# Service Information

Model: GP605 GP555 Ref. No.: FF-T01-K1-000066-01

**Location:** Developing Assembly

**Subject:** Field Measure for "Light Image" due to Degradation of Toner

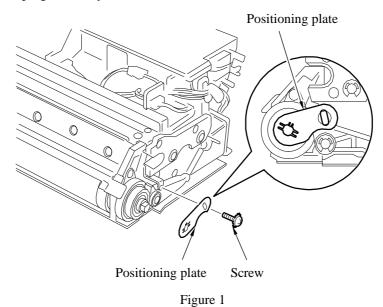
Move the magnetic pole on the developer by 5 degrees.

<Reason why moving the magnetic pole by 5 degrees improves the symptom>

The magnetic pole is located at the opposite side of the magnetic blade. Therefore, only highly charged toner is deposited on the cylinder. By moving the magnetic pole by 5 degrees, the magnetic force between the magnetic blade and the cylinder get weaken, and less charged toner can become deposited on the cylinder.

Figure 2

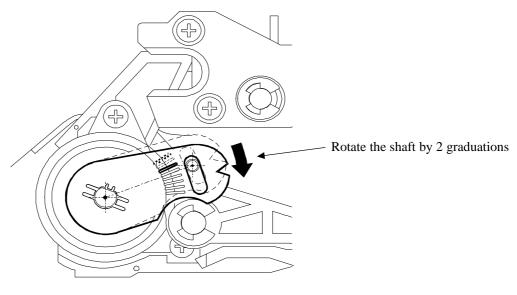
- 3) Mount the new positioning plate on the sleeve shaft.
- 4) Rotate clockwise the sleeve shaft with the positioning plate securely mounted by 2 graduations. (Move the magnetic pole by 5 degrees.)

Figure 4

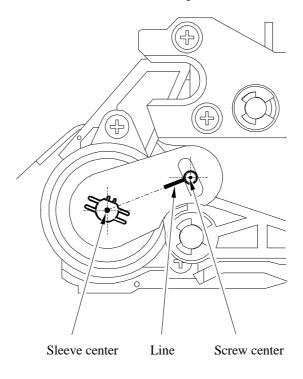
4) While the positioning plate stays without displacement as it is, draw a line as a guide on an assumed straight line connected between the center point of the sleeve and the screw.

Figure 5

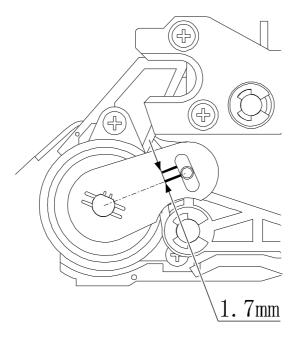
5) Draw a parallel line at 1.7mm above from the line drawn in Step 4.

Figure 6

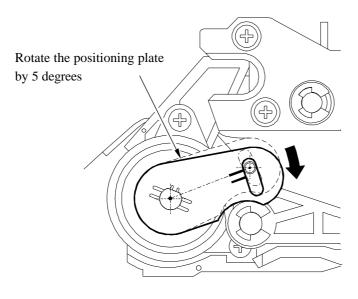
6) Rotate the positioning plate clockwise with fingers until the line drawn in Step 5 comes to the screw center. (Move the magnetic pole by 5 degrees.)
